Access Compliance Report

Public Rights-of-Way

(Curb Ramps)

Intersection ID: 45498	Main Street: COTTON_PRESS_RD	Cross Street: GRASSY_CROPS_RD	Location: W
ADA ID: A173ADD8D7A6	Ramp Type: PerpDiag	Initial Pass/Fail: Fail	Overall Compliance: No
		Severity Score: 35

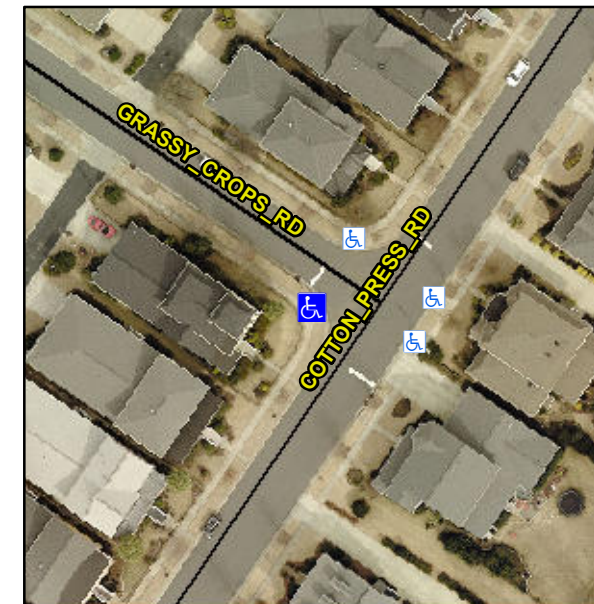
Not Found, R304.5.1, R304.2.2, R304.5.3

Compliance	Description	Data	Compliance	Description	Data
N/A	Ramp Length (in)	70.0	No	Ramp Slope (%)	13.2
No	Ramp Width (in)	36.0	No	Ramp XSlope (%)	2.5
N/A	Flare Type LT	N/A	N/A	Flare Type RT	N/A
N/A	Flare Slope LT (%)	N/A	N/A	Flare Slope RT (%)	N/A
N/A	Flare Traversable LT?	N/A	N/A	Flare Traversable RT?	N/A
N/A	Landing Length (in)	N/A	N/A	DWS Provided?	N/A
N/A	Landing Width (in)	N/A	N/A	DWS Contrast?	N/A
N/A	Landing Slope (%)	N/A	N/A	DWS Length (in)	N/A
N/A	Landing X Slope (%)	N/A	N/A	DWS Full Width?	N/A
N/A	Landing Curb? (Y/N)	N/A	N/A	DWS Offset (in)	N/A
N/A	Shared Landing?	N/A			
N/A	Gutter Ponding?	N/A	N/A	Gutter Slope (%)	N/A
N/A	Gutter Lip Ht (in)	N/A	N/A	Gutter X Slope (%)	N/A
N/A	Painted X Walk1?	No	N/A	Painted X Walk2?	No
	X Walk 1 Direction	To SE		X Walk 2 Direction	To NE
N/A	X Walk 1 Width (in)	N/A	N/A	X Walk 2 Width (in)	N/A
	X Walk 1 Slope (%)	1.5		X Walk 2 Slope (%)	0.7
	X Walk 1 X Slope (%)	0.7		X Walk 2 X Slope (%)	1.3

Remove & Replace Curb Ramp With Two New Directional Ramps or Equivalent.
